**TransGrid Revenue Proposal 2018-23**  
**Review of aspects of TransGrid's**  
**forecast capital expenditure**

**Report to**  
**Australian Energy Regulator**  
**from**  
**Energy Market Consulting associates**

**June 2017**

Figure 5: Capital investment framework overview

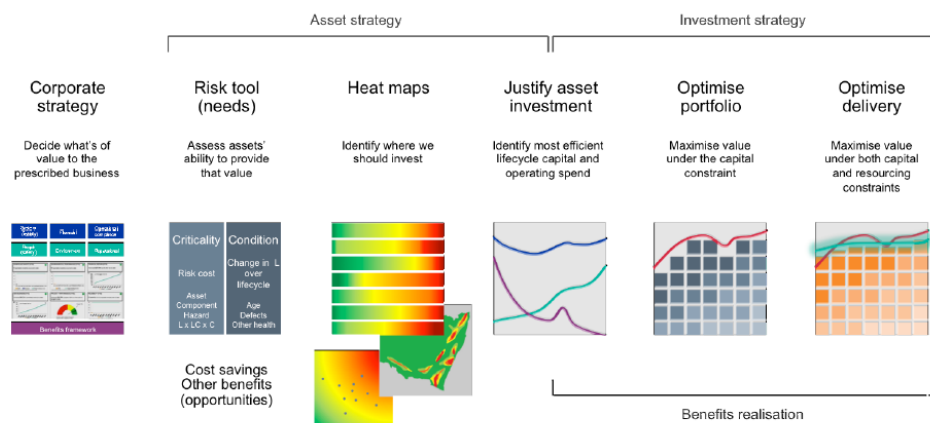
55. Whilst the elements in Figure 5 generally reflect aspects of good practice, we did not see evidence of how all of these steps were consistently applied in determination of a prudent and efficient forecast. For example, the documentation provided by TransGrid indicated to us that optimisation was done once a project was approved for delivery, and any portfolio optimisation was limited to a ranking of projects rather than optimisation of the forecast.

Figure 9: Overview of the development of risk cost

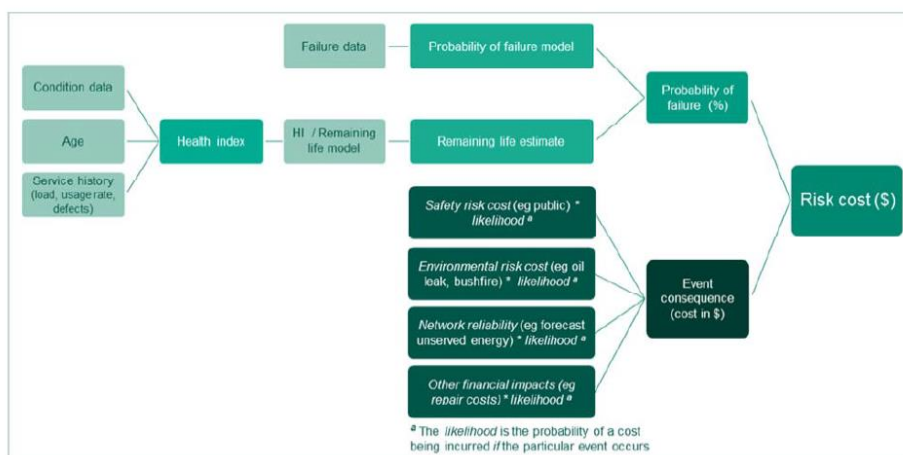
- For IT capex, we were not able to discern the relationship of the PoF calculation to the elements in Figure 9. As described in our review of IT projects and programs, TransGrid applied a step change to the PoF, from a zero base to a value of 50%<sup>24</sup> at the end of the nominated useful life.

Figure 26: Secondary systems RIN expenditure grouping – direct cost only (\$m, June 2018)

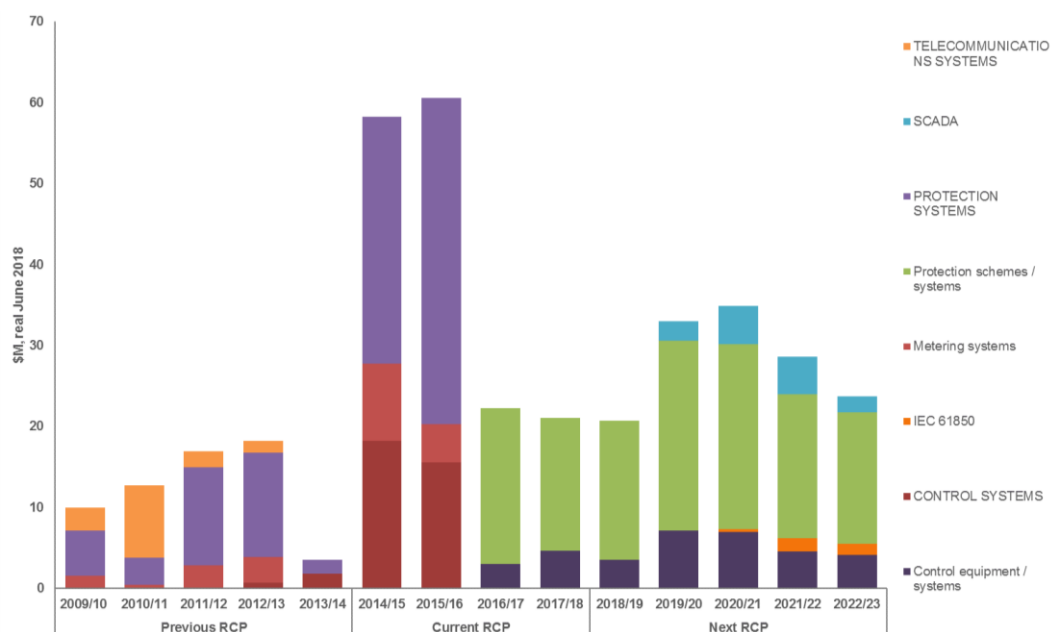
328. From Figure 26, the historical expenditure levels evident in 2014/15 and 2015/16 are not supported by statements in the *Automation Systems Renewal and Maintenance strategy*,<sup>136</sup> which suggests that this expenditure was either unplanned or associated with other replacement projects. TransGrid forecasts a continuing focus on protection system replacement/renewal in the next RCP.

Figure 28: Flow diagram representation of Ausgrid's oil-filled cable model

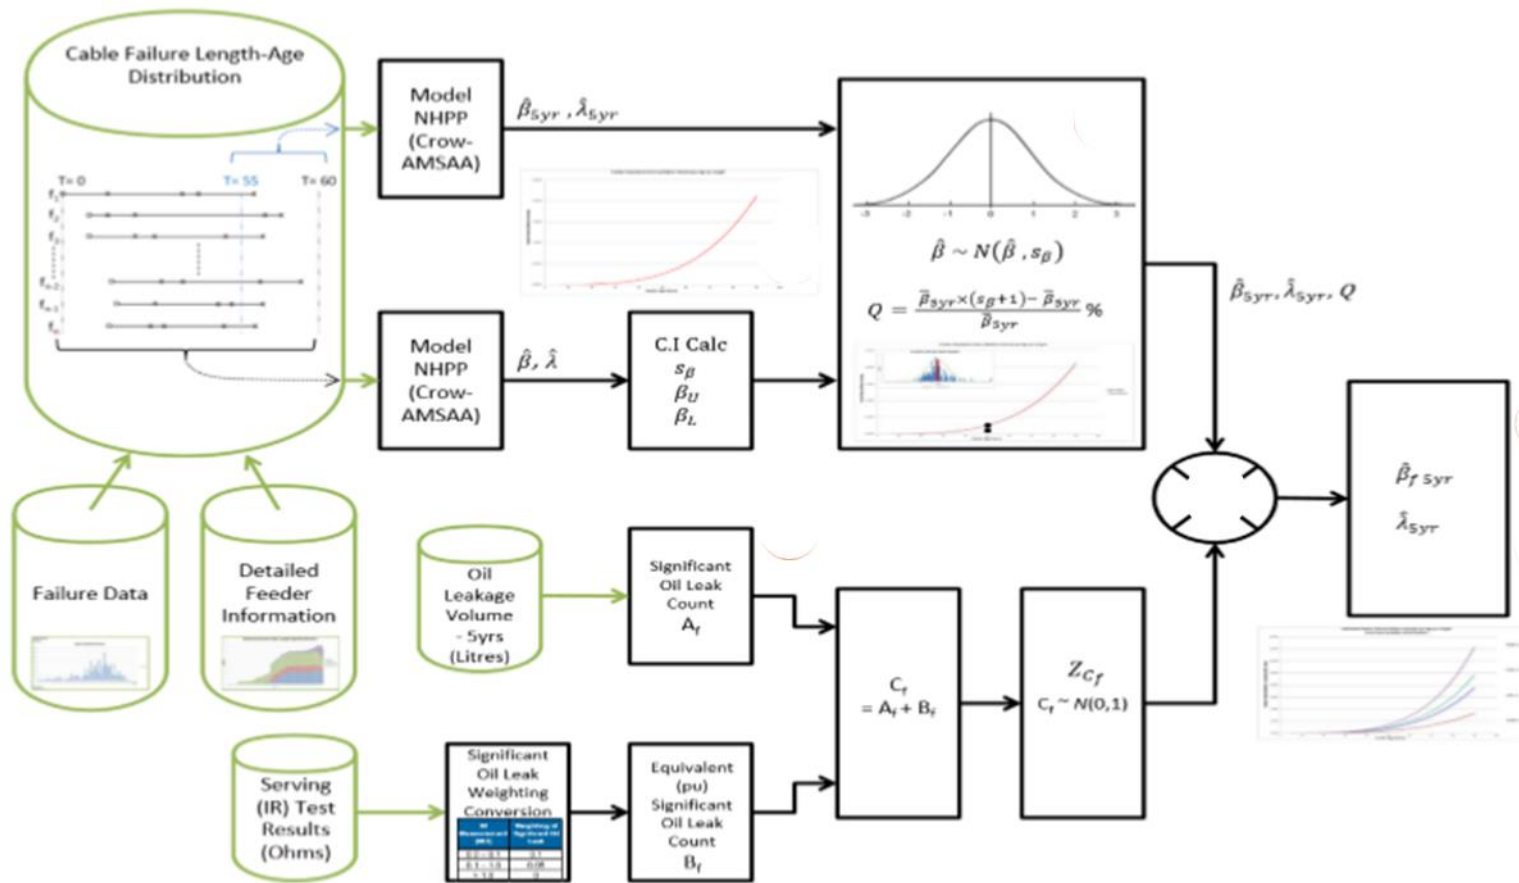
433. We consider that Ausgrid's use of the Crow-AMSAA method is suitable, noting that it has, through the steps indicated in Figure 28 above, employed its own approach to determining the failure rates for individual cables.

Figure 29: Crow-AMSAA plot of Ausgrid oil-filled cable failures (full population)<sup>182</sup>

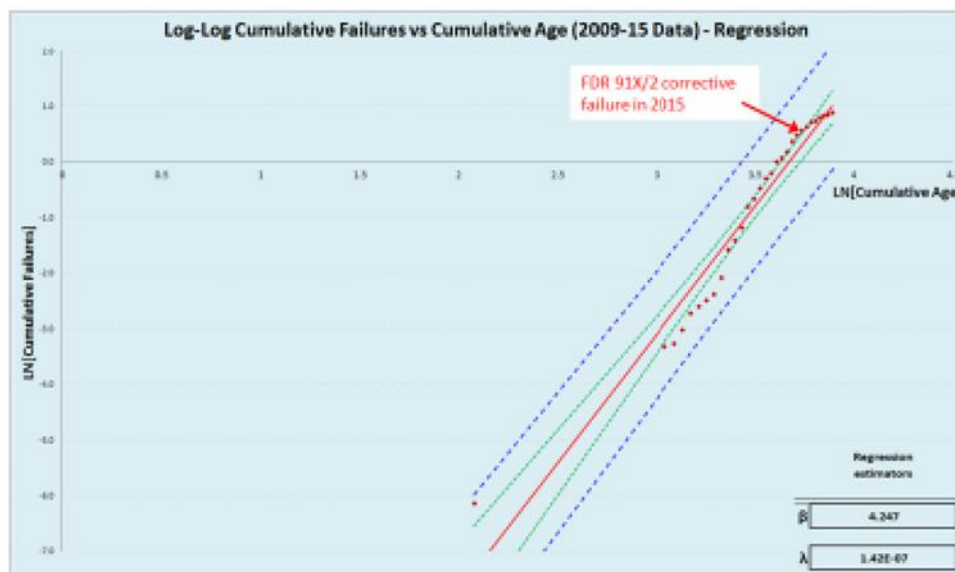
429. Figure 29 shows the Crow-AMSAA log-log cumulative failures versus cumulative age plot with the line of best fit (red line) established by simple linear regression. The slope of the line is the  $\beta$  parameter in Equation 5 and  $\lambda$  is the y-axis intercept. The 95% confidence intervals (dotted green lines) are used by Ausgrid as bounds for estimating the range of  $\beta$  values for individual cables and cable sections.

Figure 31: Ausgrid M2 (corrective) failure rate for eight Ausgrid 132kV cables (Number of corrective failures per year)

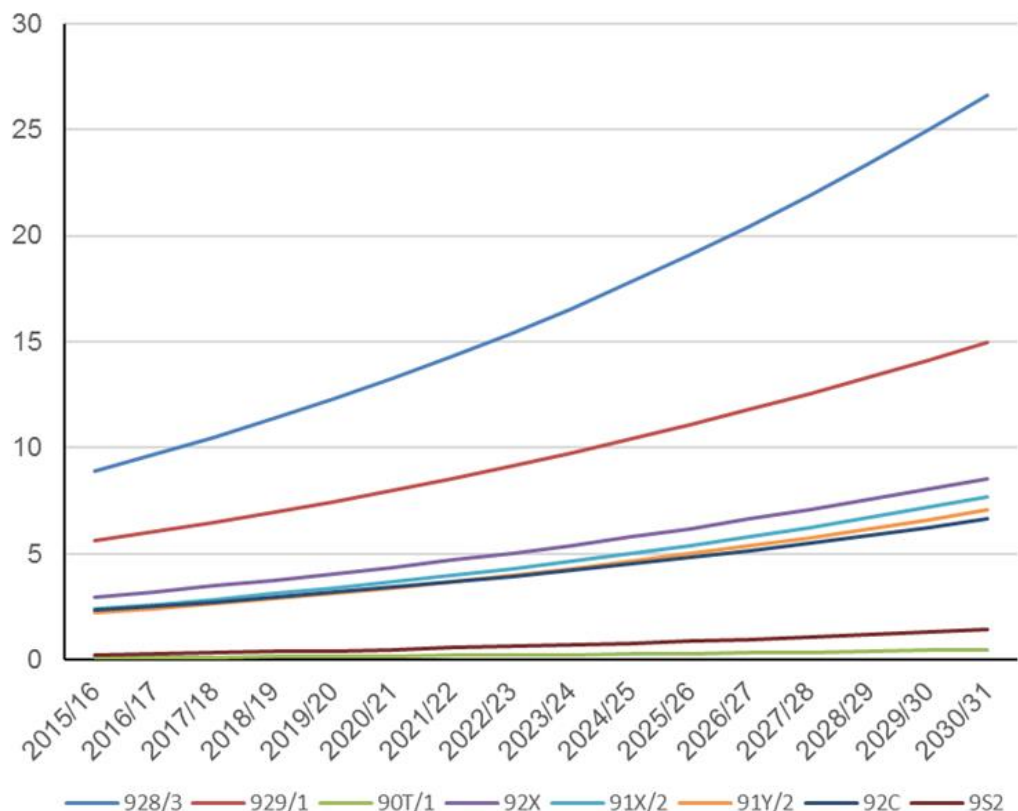
465. From Figure 31, cable 90T1 (35 years) and 9S2 (28 years) are the youngest cables with the lowest projected failure rates, and cable 928/3 is the equal oldest cable at 50 years old with the highest projected failure rate, which intuitively makes sense.

Figure 32: Ausgrid's failure rate prediction for cable 91X2

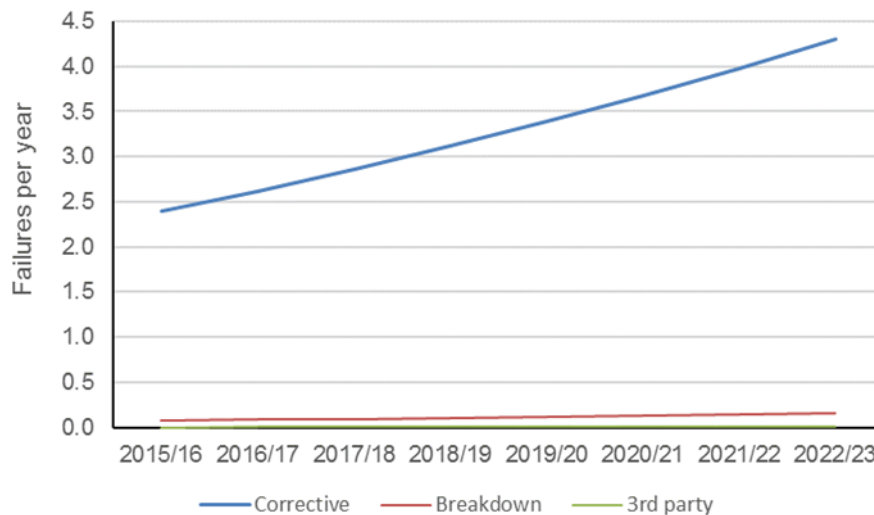
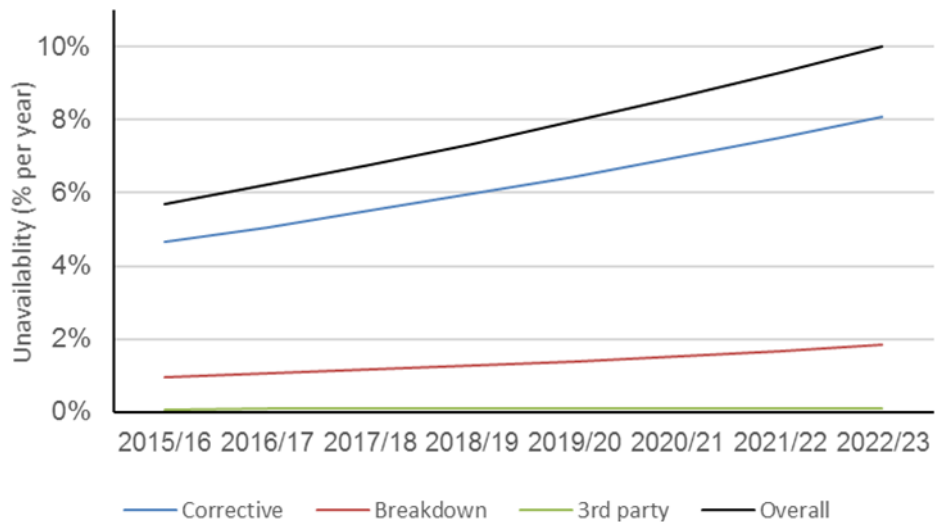
466. Figure 32 shows the results of Ausgrid's modelling for cable 91X/2. The relatively high forecast failure rates for corrective defects compared to breakdown and 3<sup>rd</sup> party modes are as we would expect based on the high volume of M2 defects included in the modelling. Similarly, the dominant contribution of the corrective defects to the total cable unavailability shown in Figure 33, is to be expected given the high failure rate and the 1.06 week MTTR.
